L:\GREYSTONE\15053 BLOOMINGTON MN\50-CD-RL

RFI-RL #34

(2) ADDED
BALCONIES

1 SECOND FLOOR PLAN - EAST
SCALE: 1/8"=1'-0"

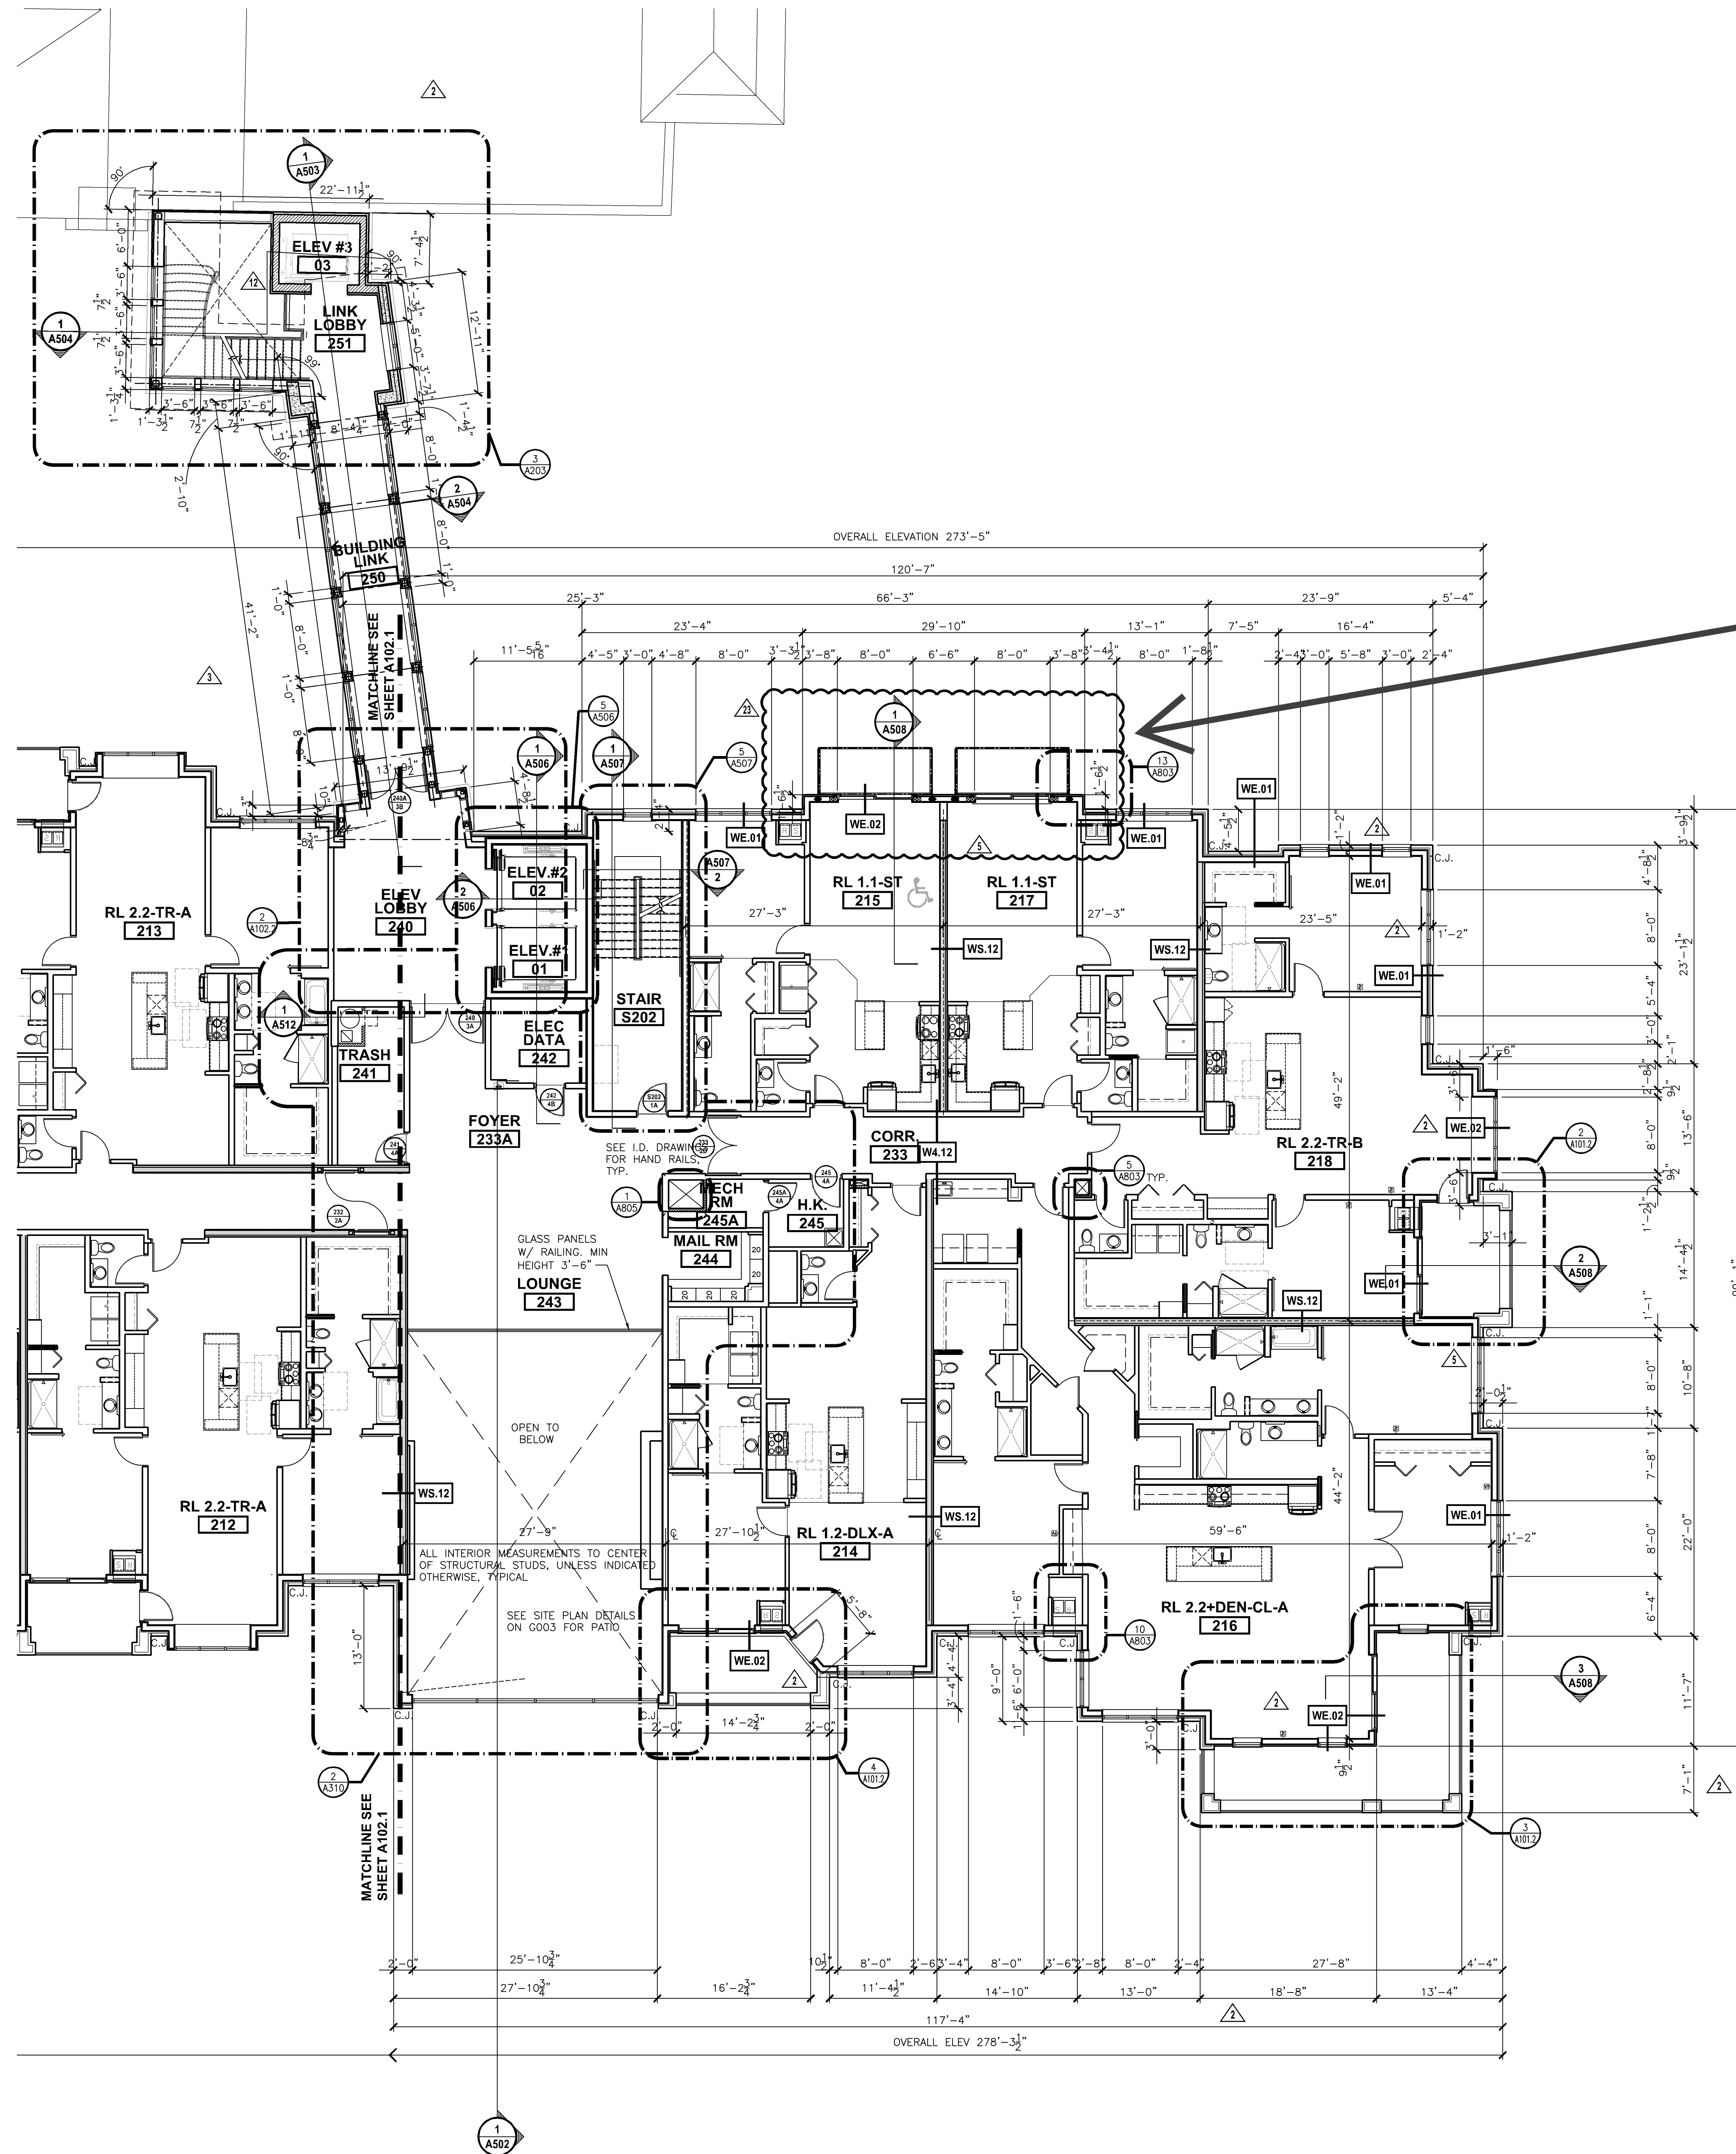
(2) ADDED BALCONIES

1 FOURTH FLOOR PLAN - EAST
SCALE: 1/8"=1'-0"

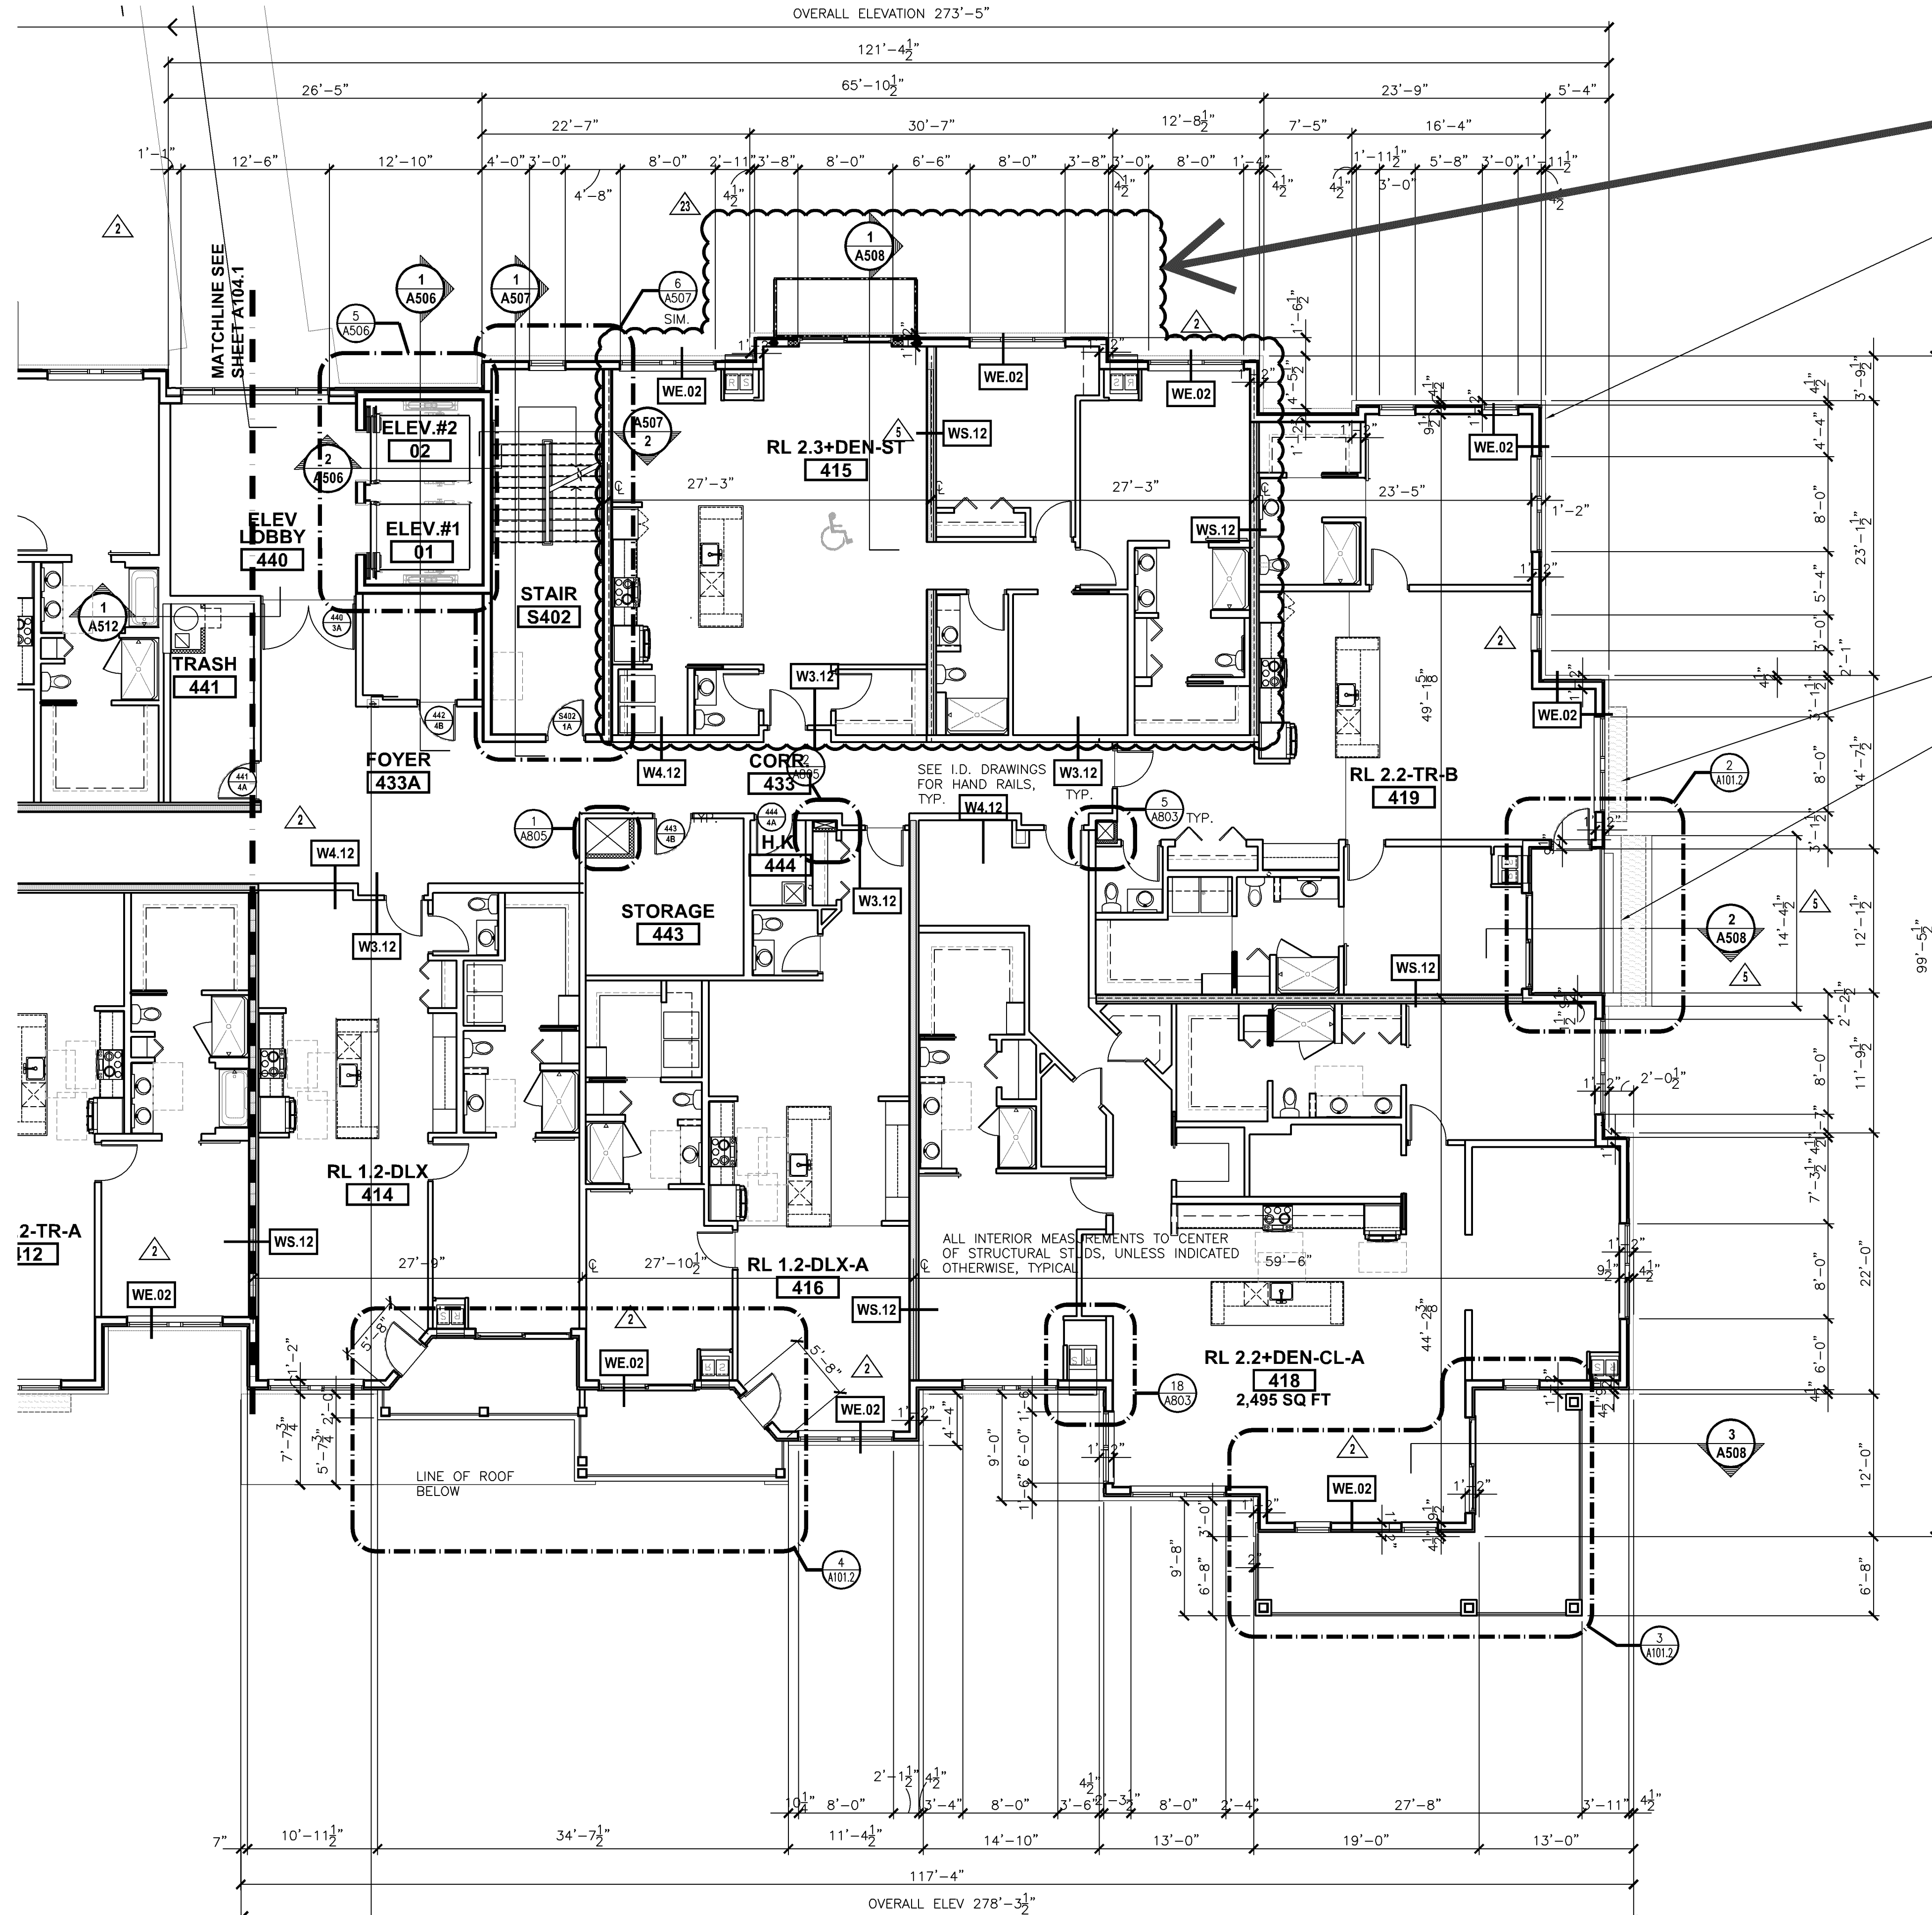
(1) ADDED BALCONY, COMBINED (2) UNITS INTO A SINGLE UNIT

1 FIFTH FLOOR PLAN - EAST

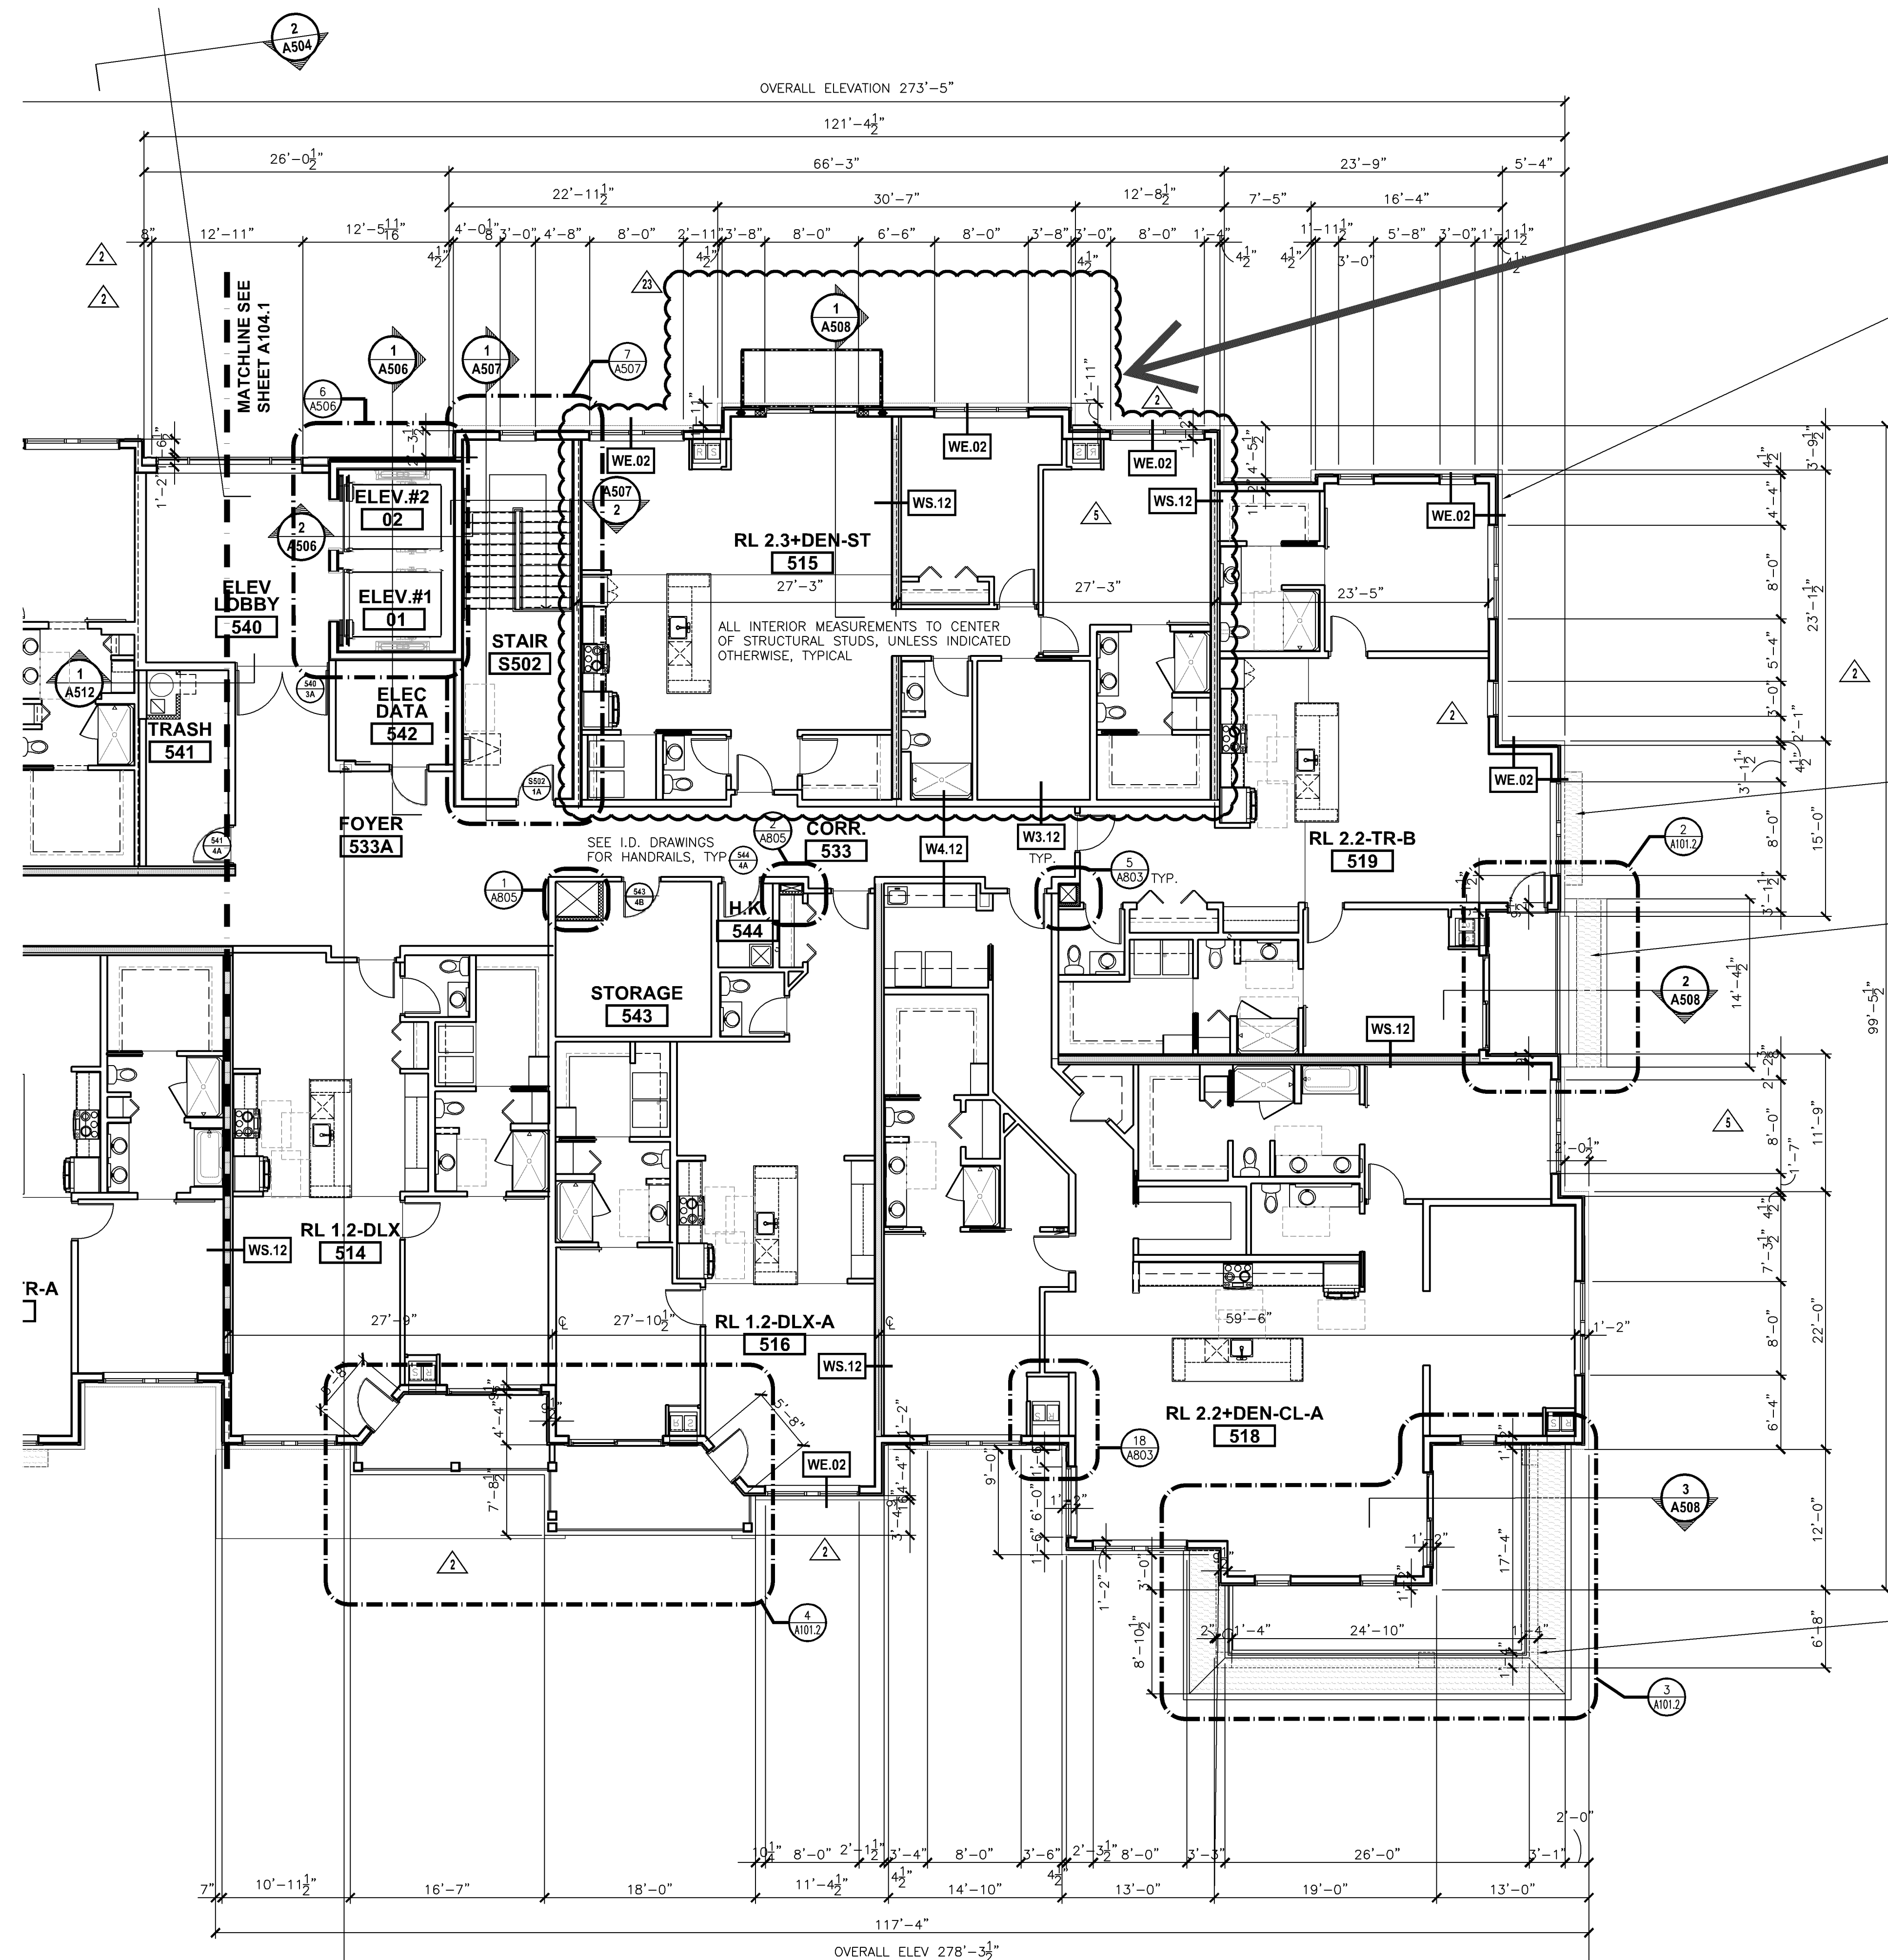
(1) ADDED BALCONY,
COMBINED (2) UNITS
INTO A SINGLE UNIT
